TO: Town of Parker Recreation Dept.
FROM: Julia Duncan, Associate Planner
DATE: January 23, 2025
SUBJECT: SP24-124; Salisbury North MDP F1 AMD 2 L1 - Park Expansion Phase 1
Review Comments 01

SALISBURY PARK NORTH PHASE 1

TOWN OF PARKER
SITE PLAN

COVER SHEET

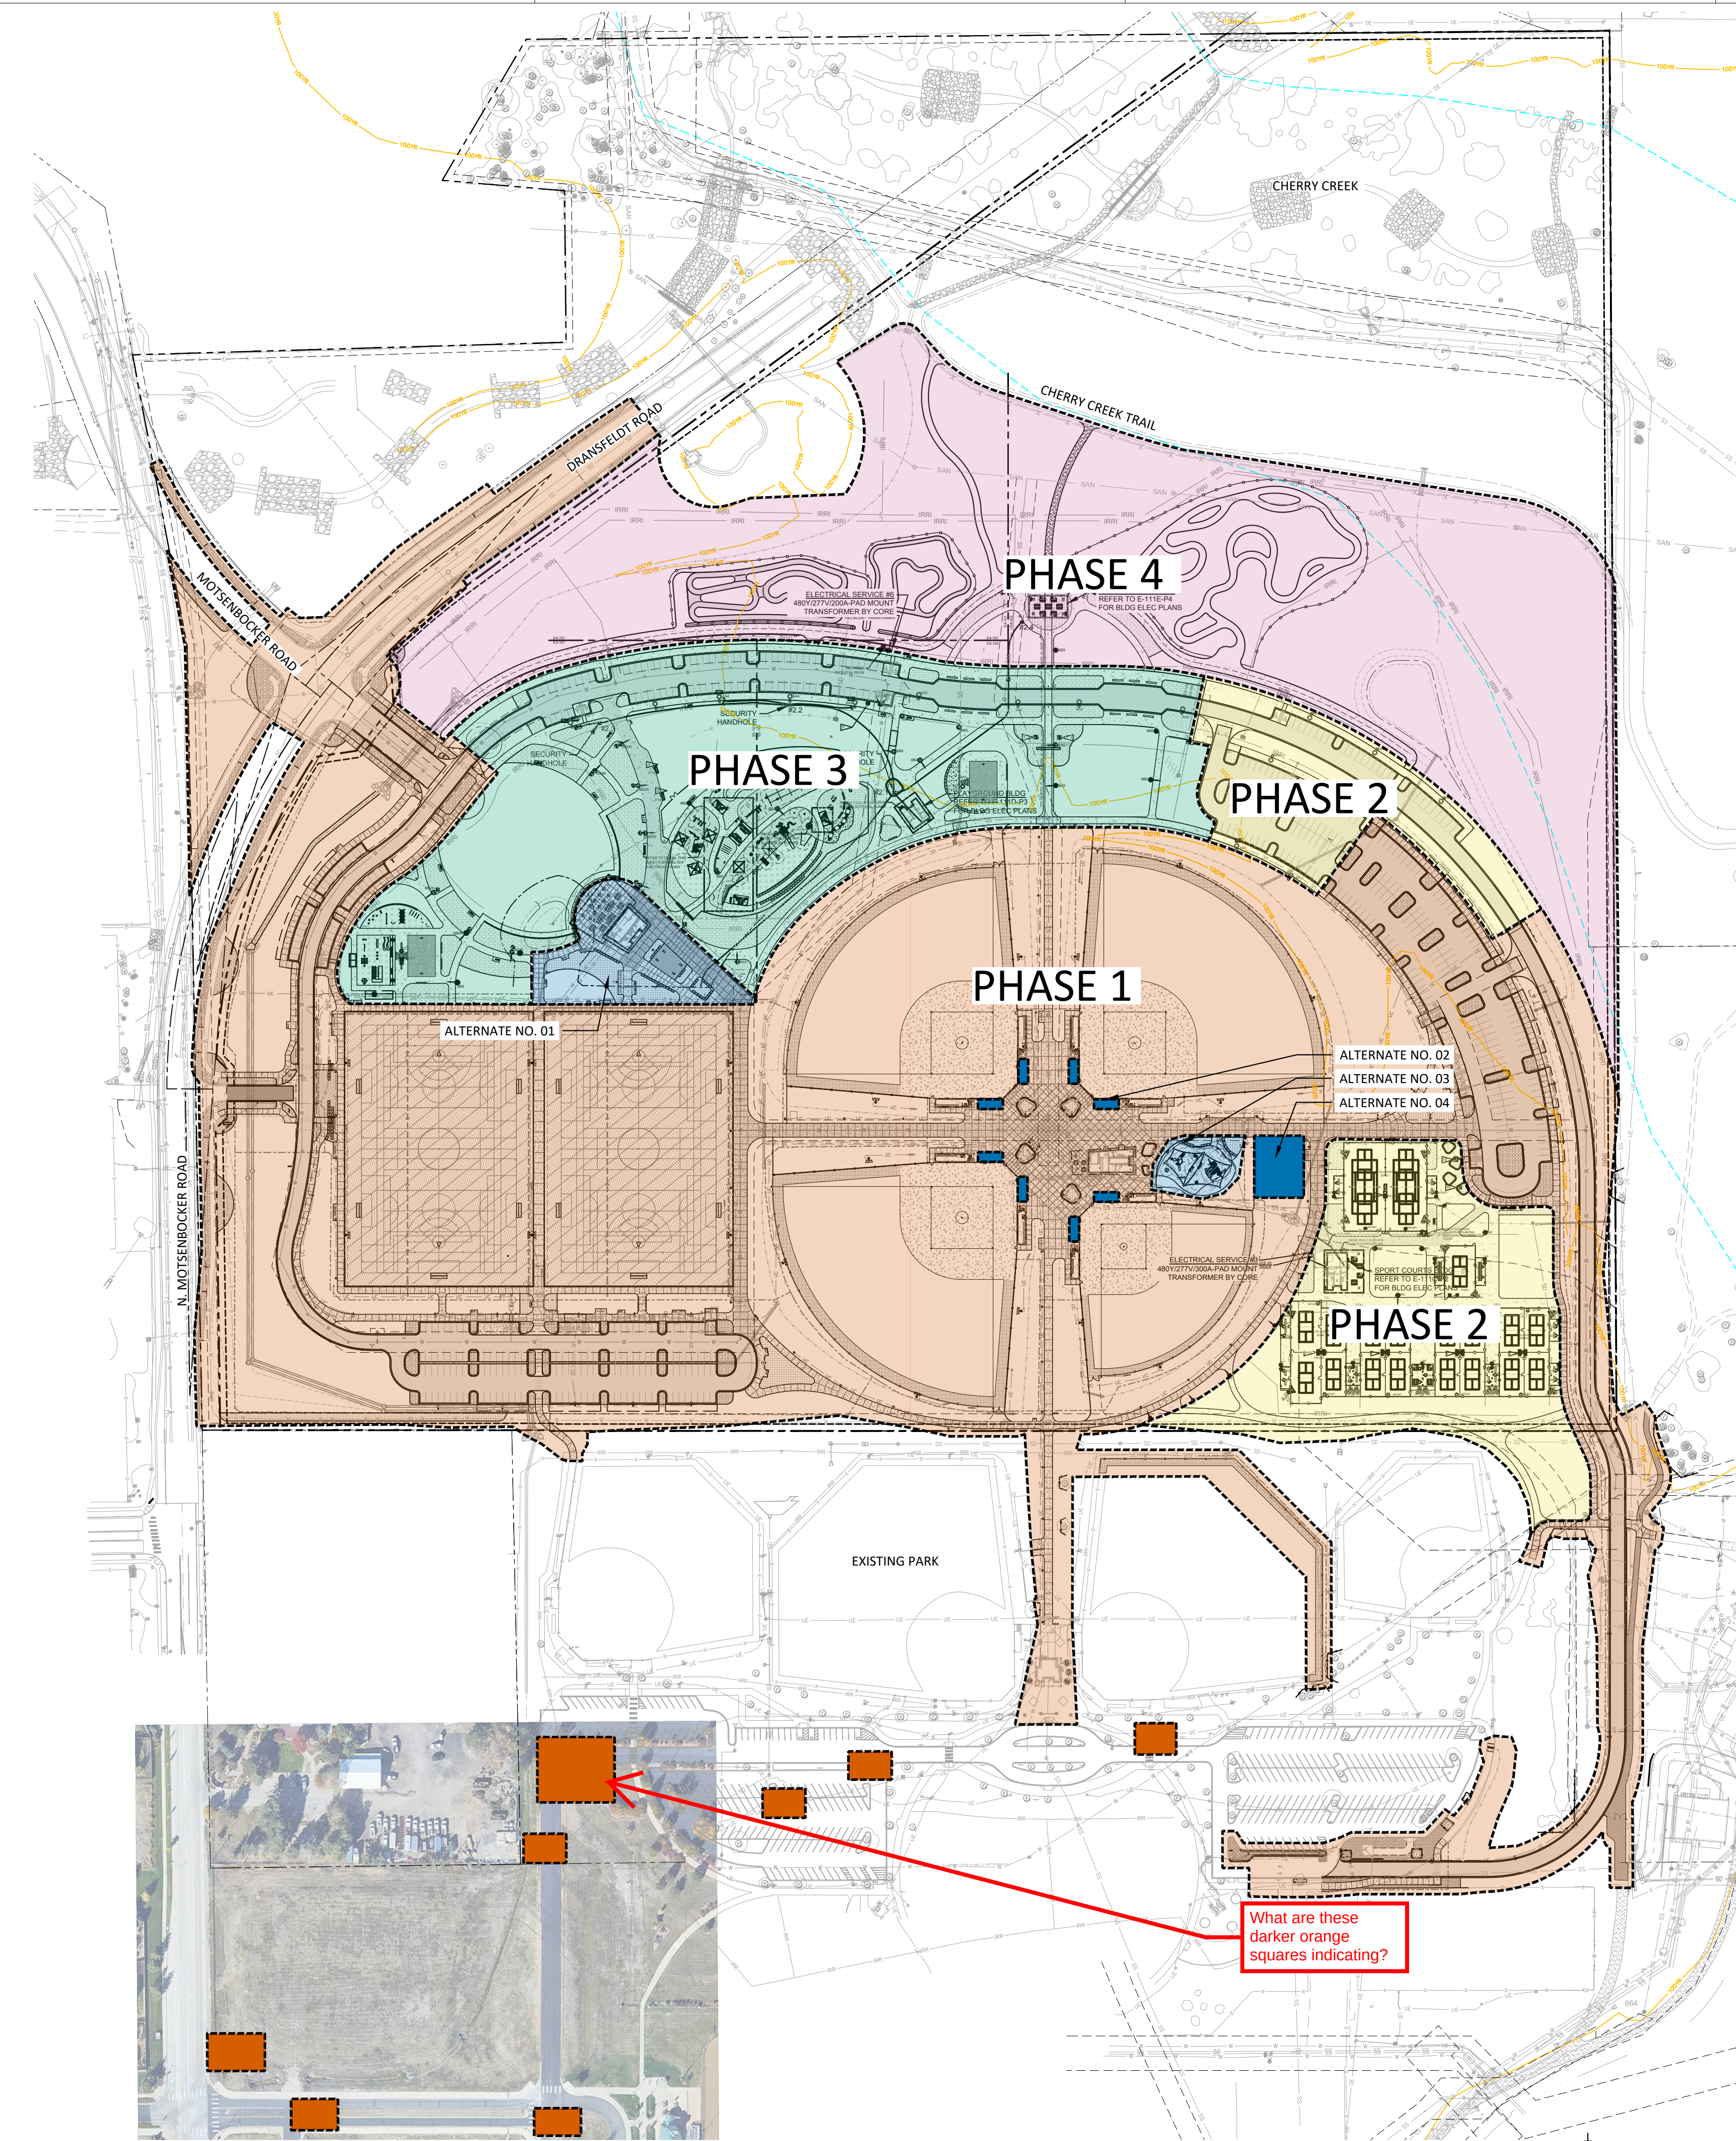
Legal Description
should be first line

Only include
acreage and lots for
this phase

Indicate what these
setbacks are for,
which building

Calc out for me,
where is this number
coming from?

COMMUNITY HUB -
EXTERIOR
ELEVATIONS

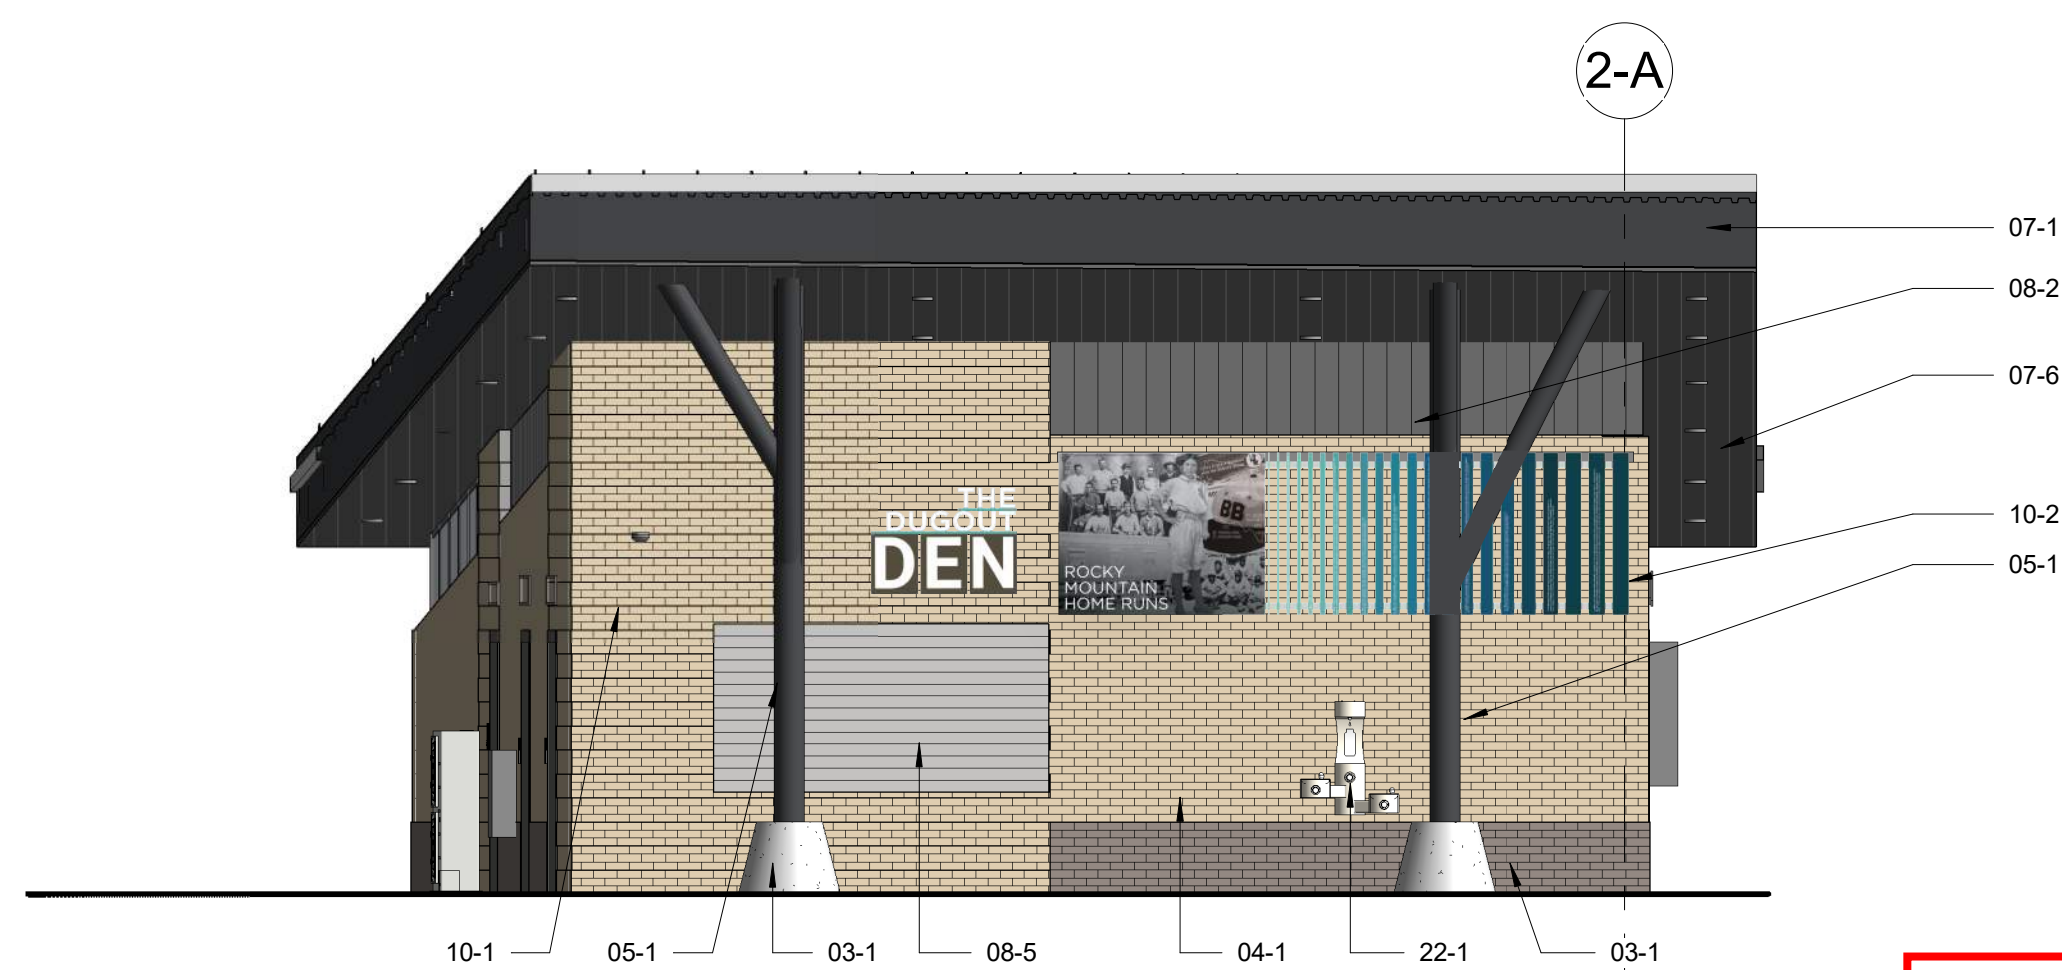
Break elevations into multiple sheets, max 2 on each sheet, dimensions all heights and widths on all elevations.

Show building footprints on same sheet of elevations, indicating plane breaks

Include a small site plan on all elevations building sheets showing where these buildings are

Provide more detail on graphics/application/permanency...etc.

Can you incorporate any of the glazing on this facade

Is there any wall mounted lighting anywhere?

Please label
